Block 7

1. Inconsistent plans:

SCHEMATIC LAYOUT

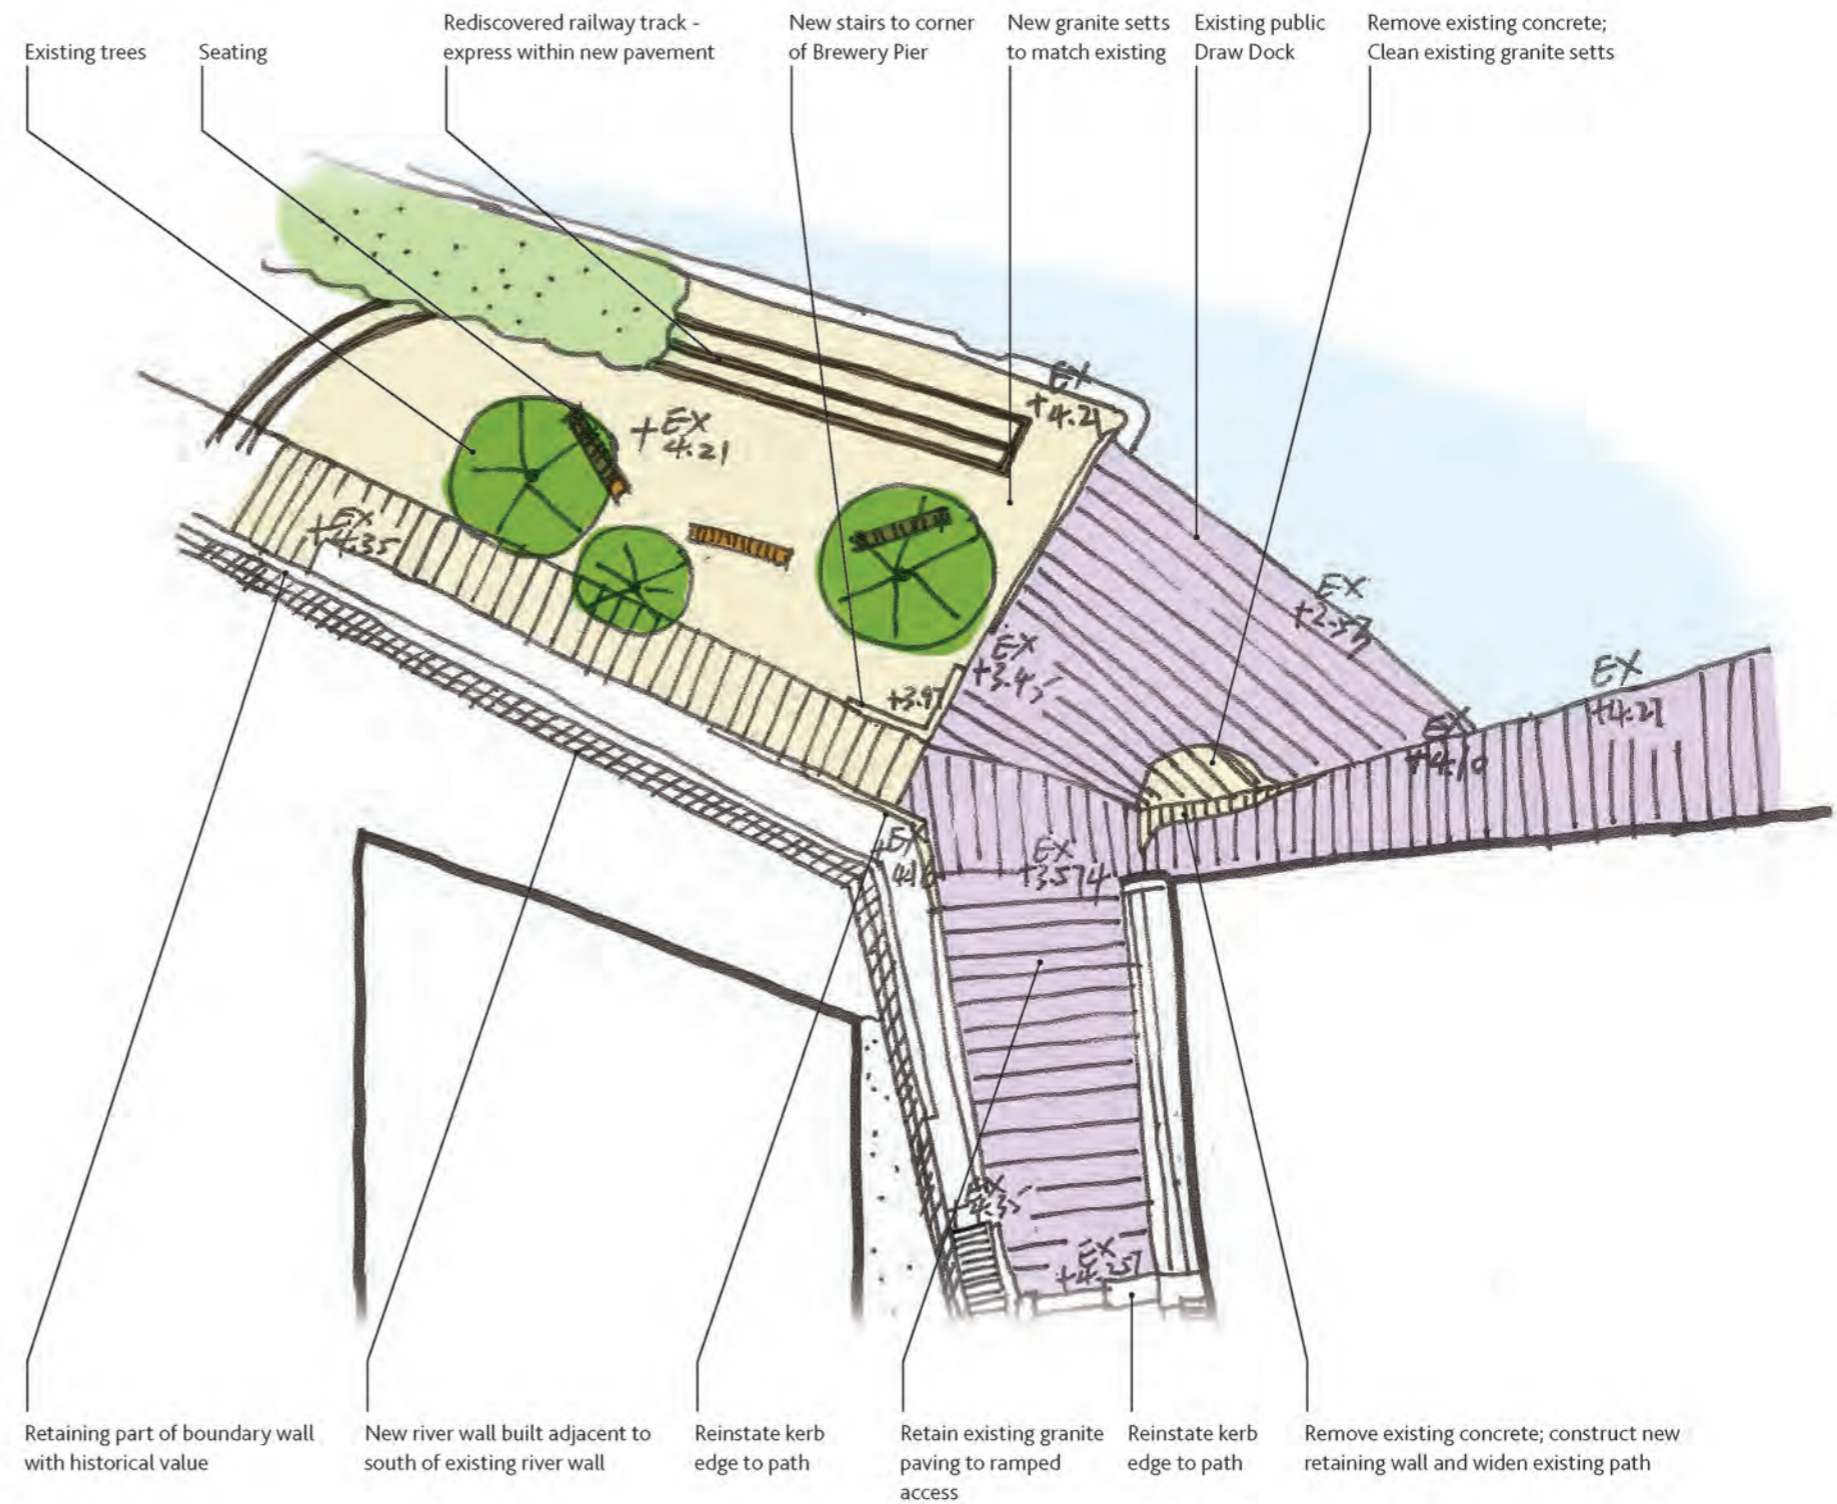
4. Towpath – Public draw dock (ie Bulls alley)

An option to upgrade the Towpath, in particular around the Bulls Alley and proposed Rowing Club end has been included in our Planning Application as a recommended approach to this area – outside our red line boundary.

Strategic upgrading of the existing facilities will be carried out to improve the quality of the Towpath and additional upgrade works to the path and revetment wall are planned by relevant authorities.

Existing granite setts will be cleaned, and retained with new granite setts to match at the eastern end of the Towpath. Benches will be provided at key locations.

Pruning of vegetation at some areas will open up the views to the river Thames.

Life saving equipment and signage will also be located as directed by Port of London Authority to comply with health and safety requirements on the Towpath.

Proposed roof plan of secondary school

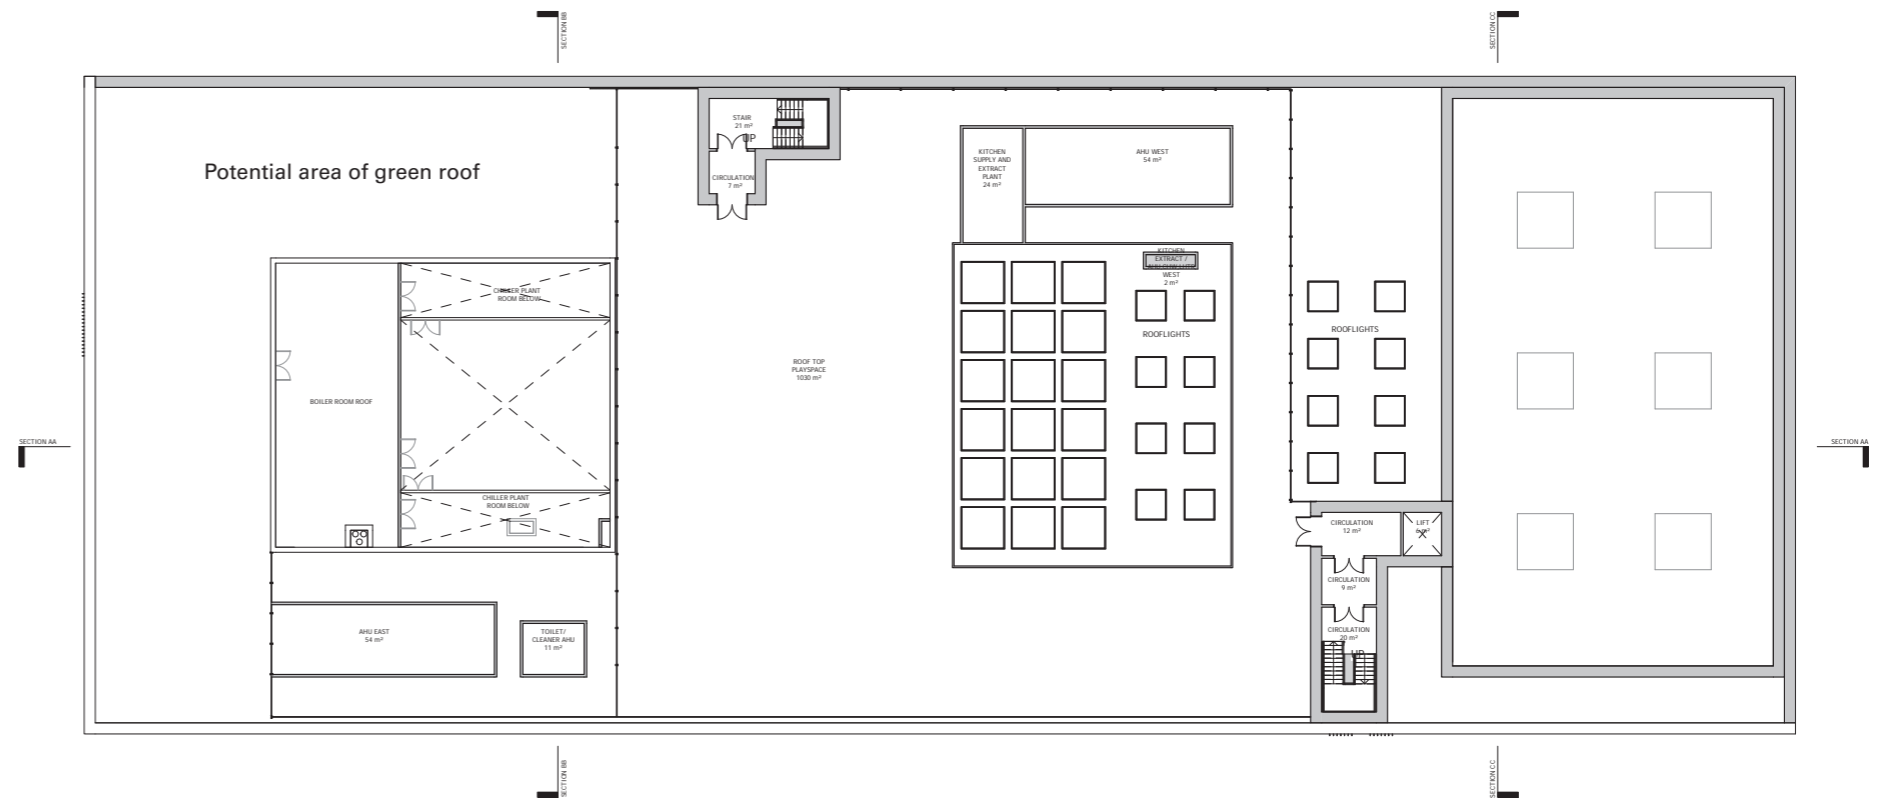
Treatment is unclear. This should include green roof – show. Provide more details of screen around roof – this metal cladding screen appears obtrusive and unacceptable. This should be removed / replaced with softer more recessive treatment. What is the screen around the roof – appears obtrusive.

Accessible areas of the roof include plant areas and play space. Play space areas will have a coloured rubberised finish. The remainder of the roofscape will have a different flat roof finish (TBC) and will incorporate rooflights that are raised above surface level.

An area of roof to the North of the building could potentially be utilised as green roof, further to agreement with the ESFA.

Fencing Detail

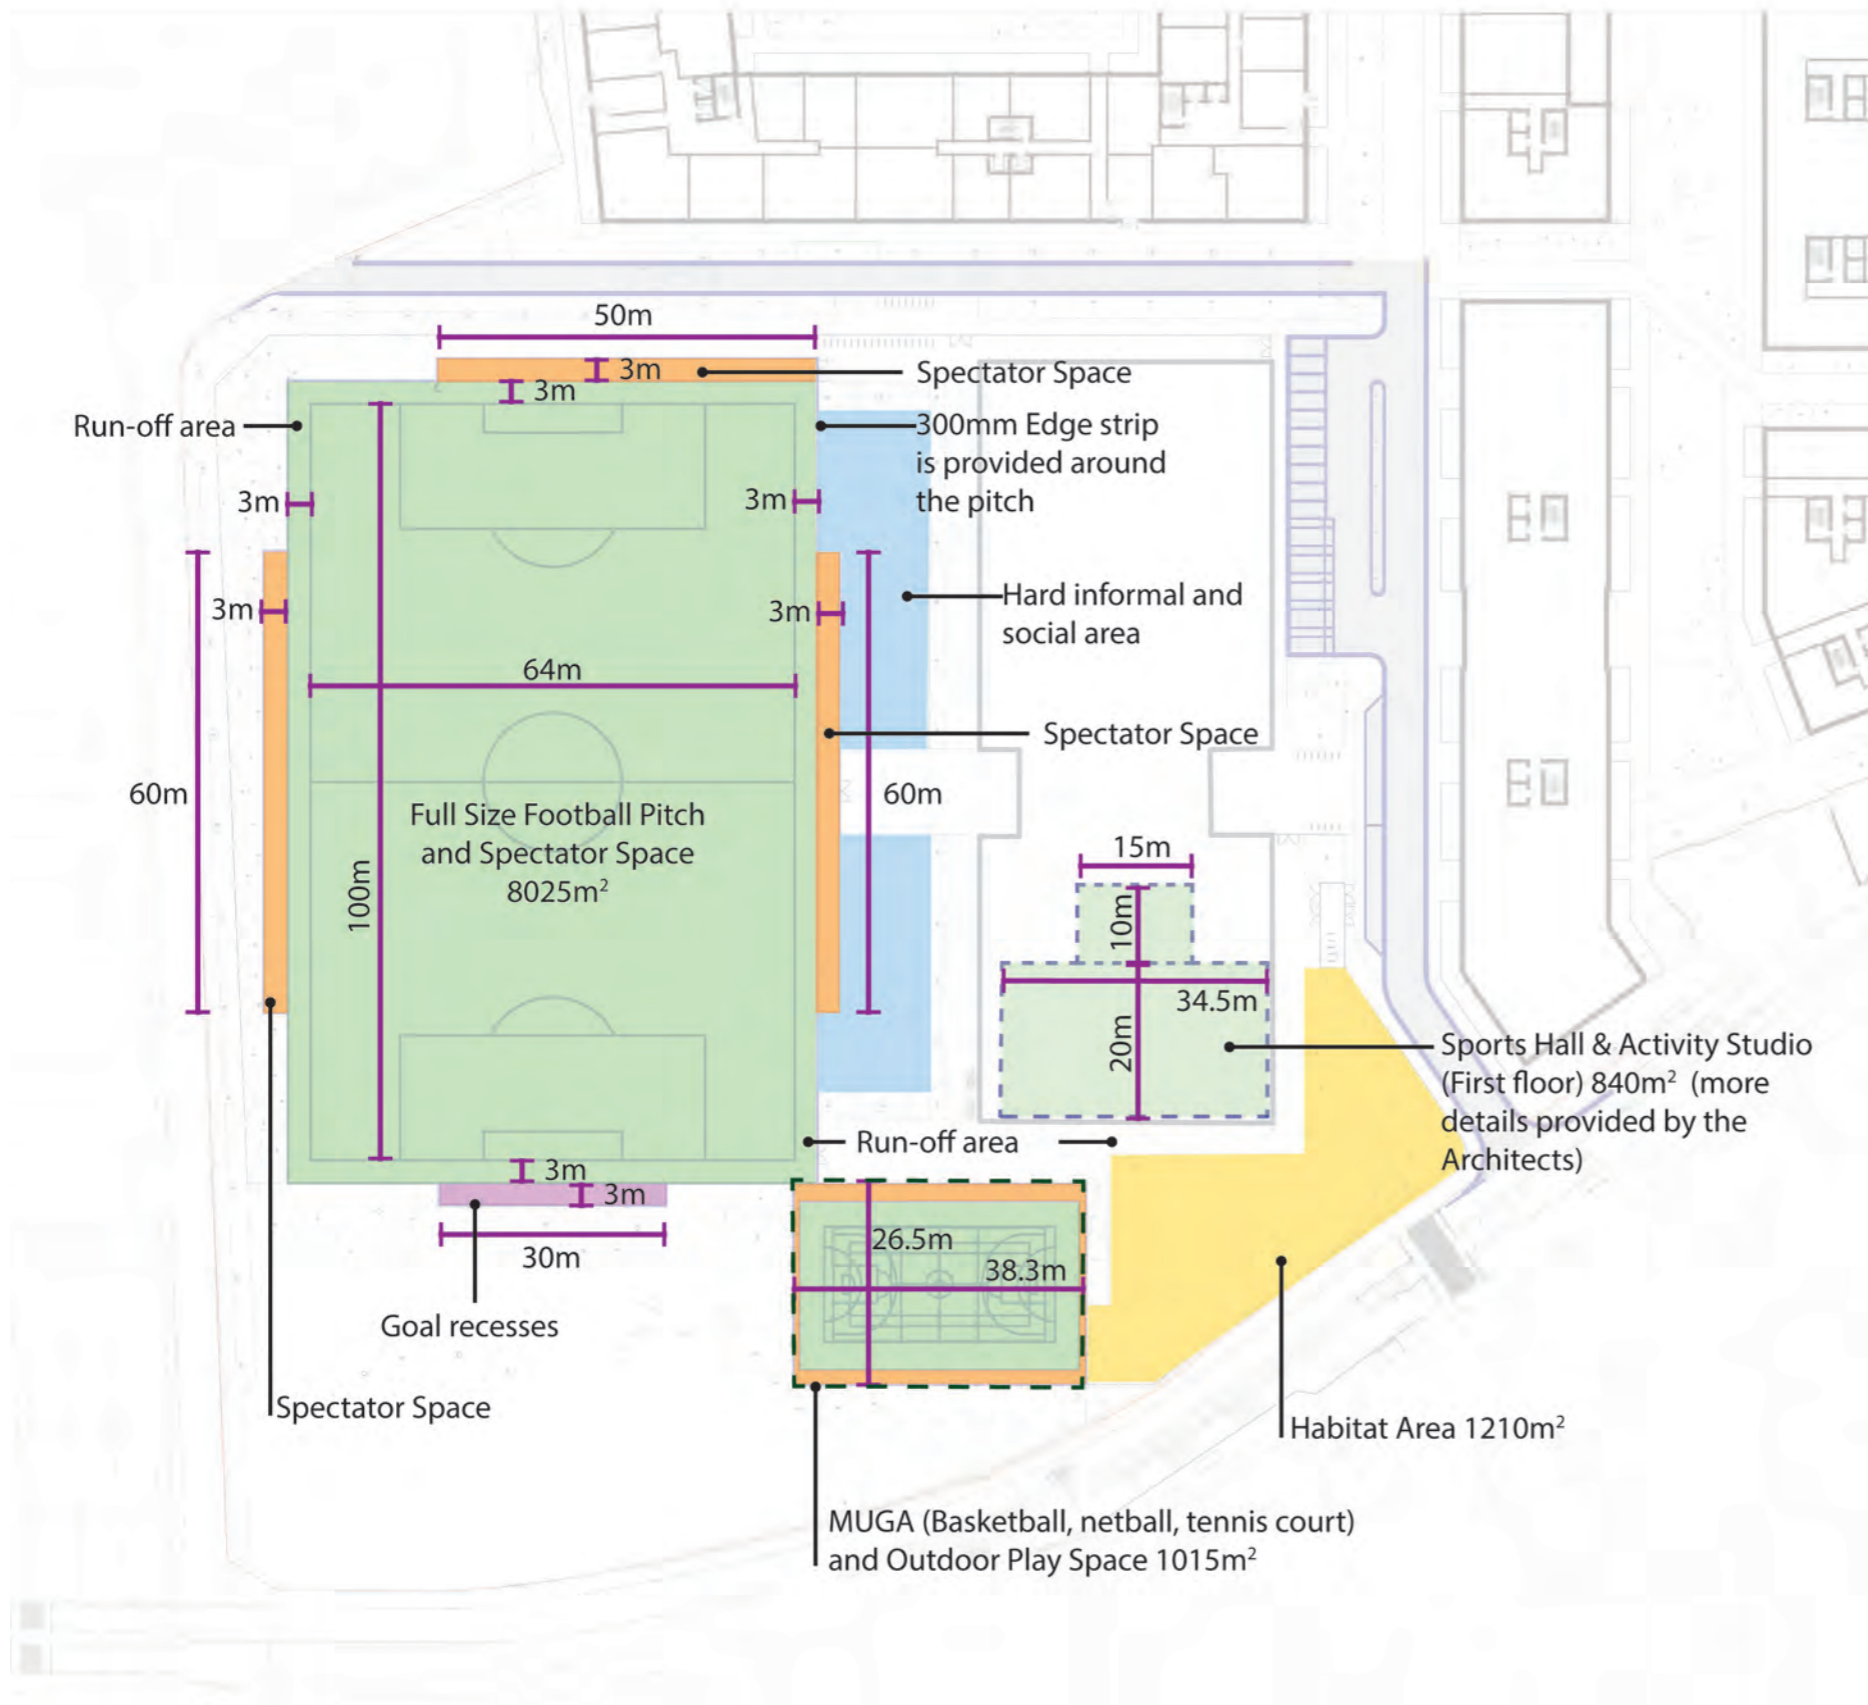
Appearance of MUGA and associated sport facilities. It is unclear what these will look like – provide details of: Surfacing, Lighting and Boundary Treatment.

Fencing to Sports Pitch and MUGA, as well as school grounds and Habitat Area will be in accordance with ESFA requirements and Sport England recommendations. Lighting has been designed for the sports pitch to designated FA levels (Category 2&3) – refer to Sports Pitch Lighting Assessment 547-(010)-RP-EX-LA.

The 4.5m, 3m and 1.2m high fence are all twin bar super rebound and black in colour. Products from manufacturers such as ZAUN and Sports & Safety Surfaces or similar approved will be used.
